U.S. Nuclear Regulatory Commission  
Attn: Document Control Desk  
Washington, DC 20555Peach Bottom Atomic Power Station, Units 2 and 3  
Renewed Facility Operating License Nos. DPR-44 and DPR-56  
NRC Docket Nos. 50-277 and 50-278

Subject: Relief Requests Associated with the Third and Fourth Inservice Inspection (ISI) Intervals and the First and Second Containment Inservice Inspection (CISI) Intervals - Response to Request for Additional Information Concerning Relief Request CRR-13

**RESPONSE TO REQUEST FOR ADDITIONAL INFORMATION  
REGARDING RELIEF REQUEST CRR-13 ASSOCIATED WITH THE  
FIRST AND SECOND CONTAINMENT INSERVICE INSPECTION INTERVALS  
PEACH BOTTOM ATOMIC POWER STATION, UNITS 2 AND 3**

**Drawing 6280-S-188**

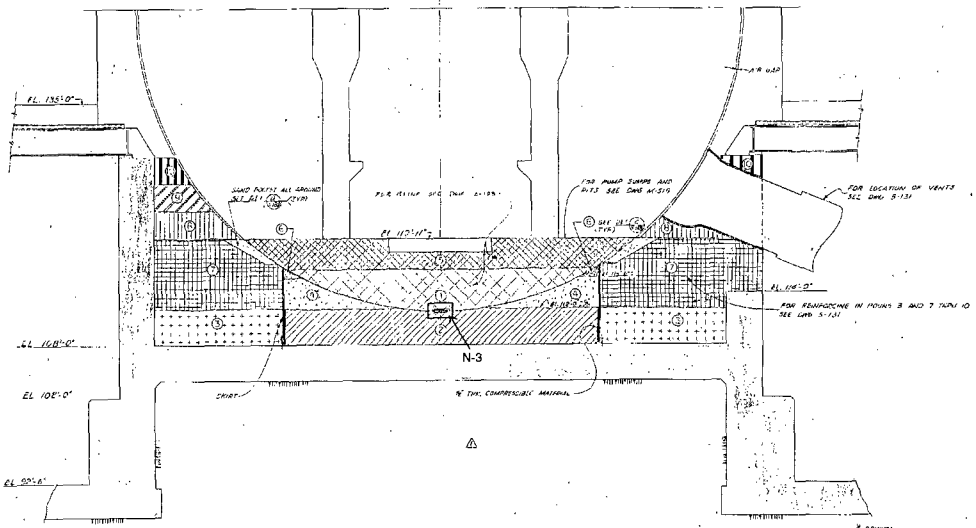
RAI-1) To facilitate the NRC staff's understanding of the as-constructed configuration of the drywell with the embedded construction manway N-3, please provide a detail drawing of a vertical section of the drywell passing through the location of the N-3 manway. Please provide a detail that shows the as-constructed structural configuration of the drywell including its concrete components (i.e., concrete floor, concrete foundation and concrete wall with important dimensions and elevations).

RAI-2) Please confirm if the seal weld for the manway penetration was radiographed and tested for leak-tightness (indicate method used) prior to being covered with concrete.

Drawing 6280-S-188 is contained in Attachment 2. This drawing represents the as-constructed structural configuration of the Peach Bottom Atomic Power Station (PBAPS), Units 2 and 3 drywells, including their concrete components.

Relief Request CRR-13 is based on the drawings and the Specification for Reactor Drywell and Suppression Chamber Containment Vessels. Note 1 on drawing S-188 states that a pneumatic test was performed prior to the concrete pours and the weld was seal welded. A search of construction records could not confirm that radiograph was performed on the seal weld for the manway path.
